STAFF RECOMMENDATION

**1628 Shelby Avenue
December 18, 2019**

Application: Violation—Outbuilding Constructed Without a Permit; Setback Determination

01 SITE PLAN

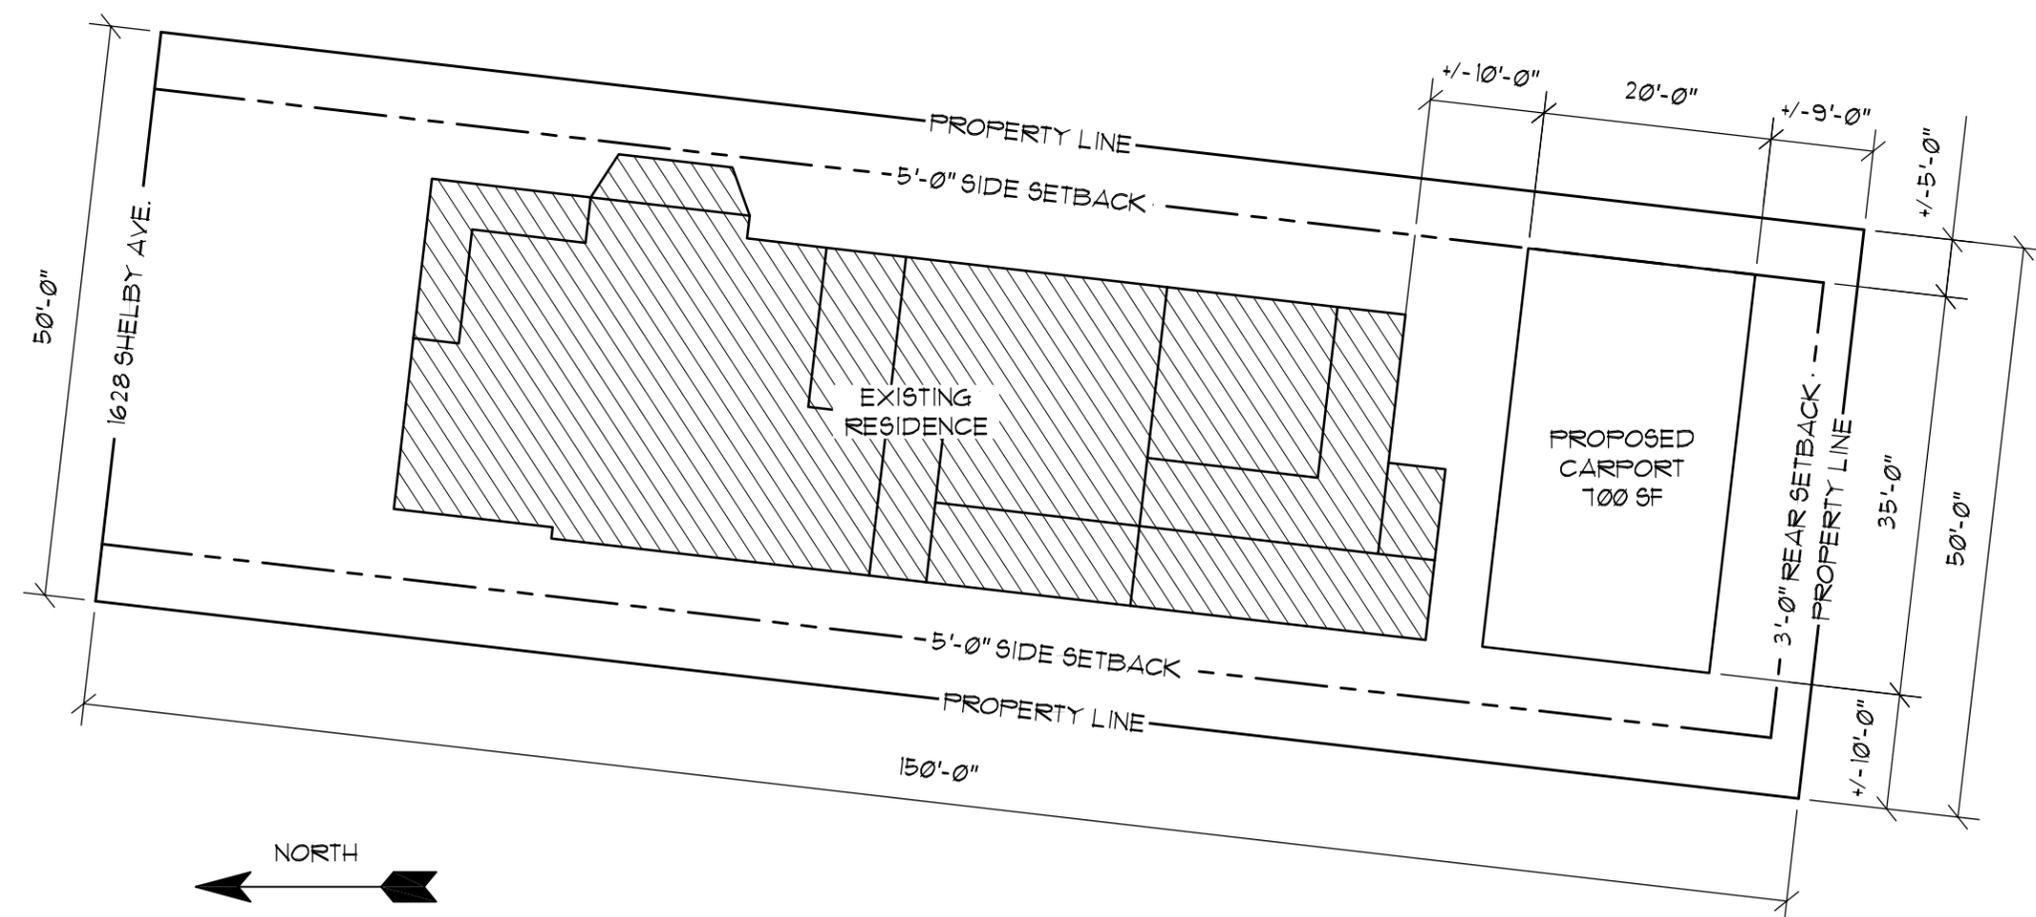
As constructed, the carport does not meet the left-side street-setback from South 17th Street and does not meet the minimum separation from the principal buildings. The bulk zoning standards require a minimum side setback of 10' from a local street. The structure, however, was constructed five feet (5') from the left-side property line along South 17th Street. The applicant has requested a setback determination to reduce the left-side setback from ten feet (10') to five feet (5'). Staff does not recommend approval of the setback determination since the outbuilding could be shifted closer to the right-side property line and meet both side setbacks.

According to the site plan, the carport is located five feet (5') from the upper level covered porch/landing (Figure 3). The structure is much closer to the rear addition when factoring in eave depth. The purpose of the separation requirement is to meet Section II.B.2 for open space and to prevent the appearance of an attached garage. Since the subject property is mostly flat and has a typical lot depth, an attached garage would not meet the design guidelines at this location. In this case, the proximity of the carport to the primary structure creates the look of an addition that does not meet the design guidelines for new construction. Also, while the previous rear additions were constructed prior to the overlay, they more than doubled the footprint of the historic house and included both an attached garage and carport before those elements were converted to living space. The two existing curb cuts along the South 17th Street frontage were likely in the locations of those elements.

Recommendation: Staff recommends disapproval of the application and setback determination, finding that the project does not meet Sections II.B.2. (Scale), II.B.8.a. (Roof Shape), and II.B.8.b. (Setbacks) of the *Lockeland Springs-East End Neighborhood Conservation District: Handbook and Design Guidelines*.

EXT. ELEVATIONS

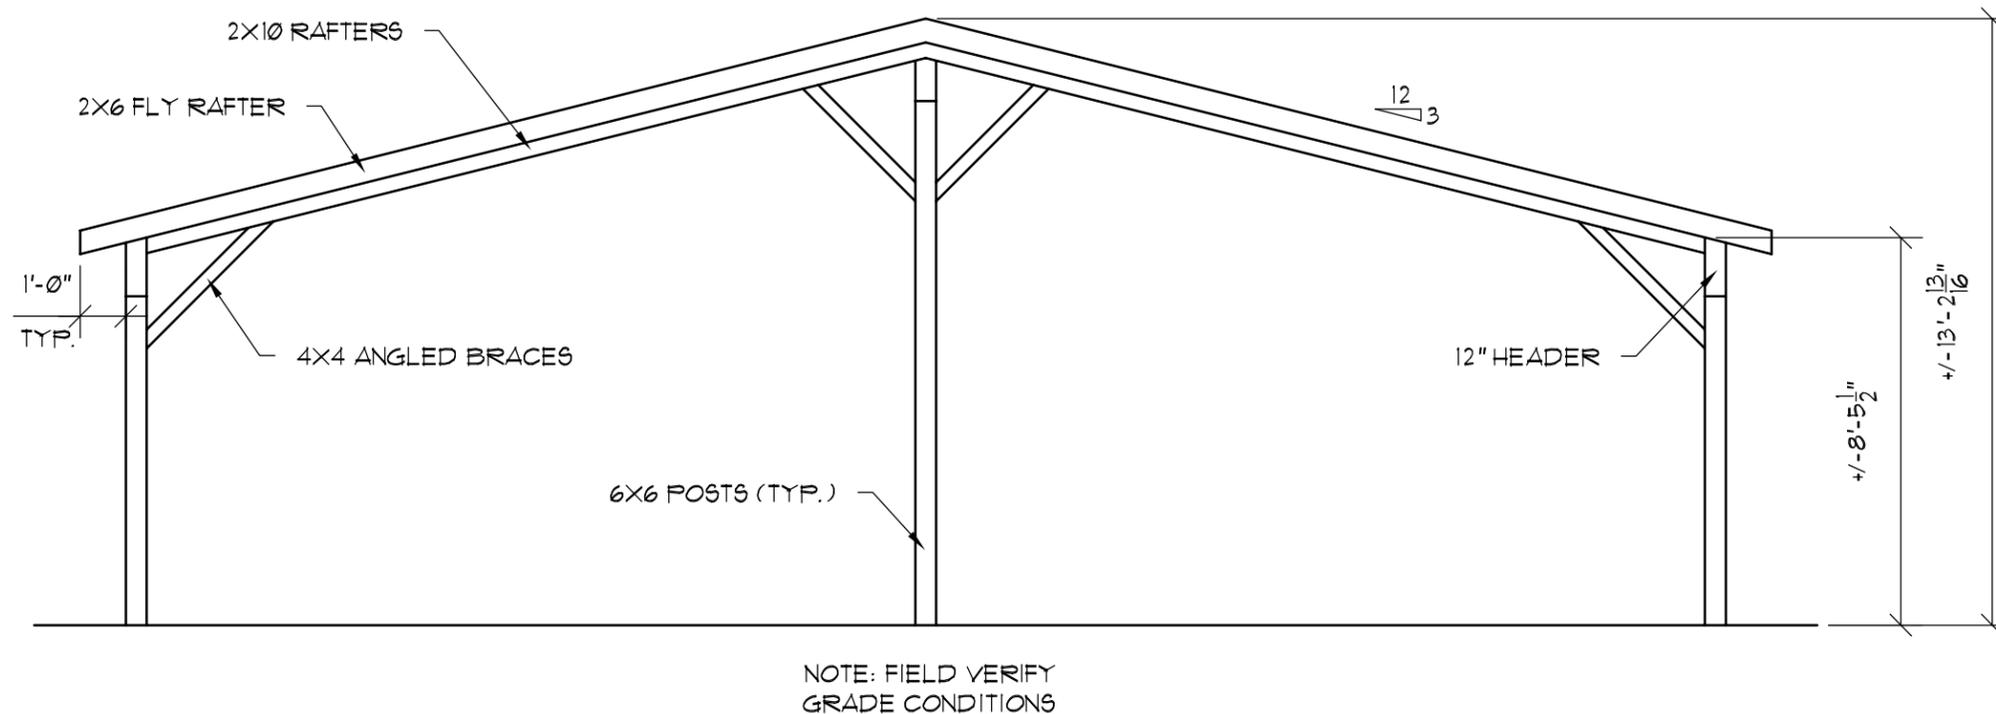
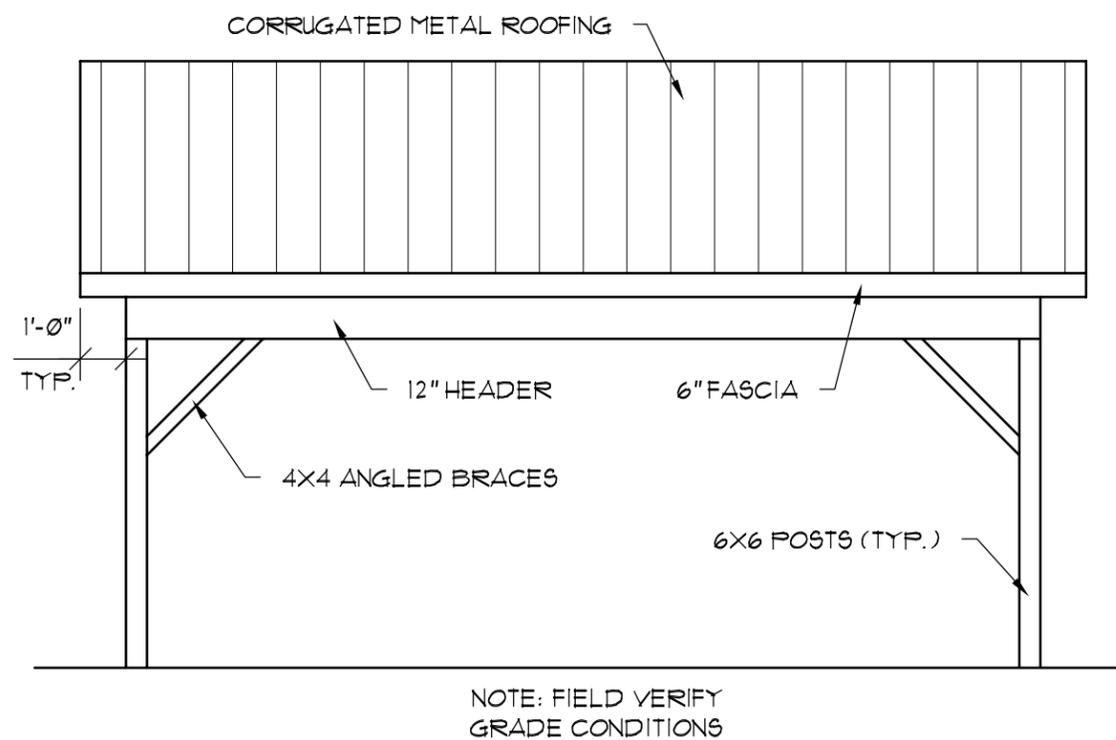
The primary roof form is gabled, which could be appropriate. However, the roof pitch is 3/12, and the design guidelines for outbuildings state that the roof slope should typically be a minimum of 4/12. Staff finds that the proposal does not meet Section II.B.8 of the design guidelines for roof shape.
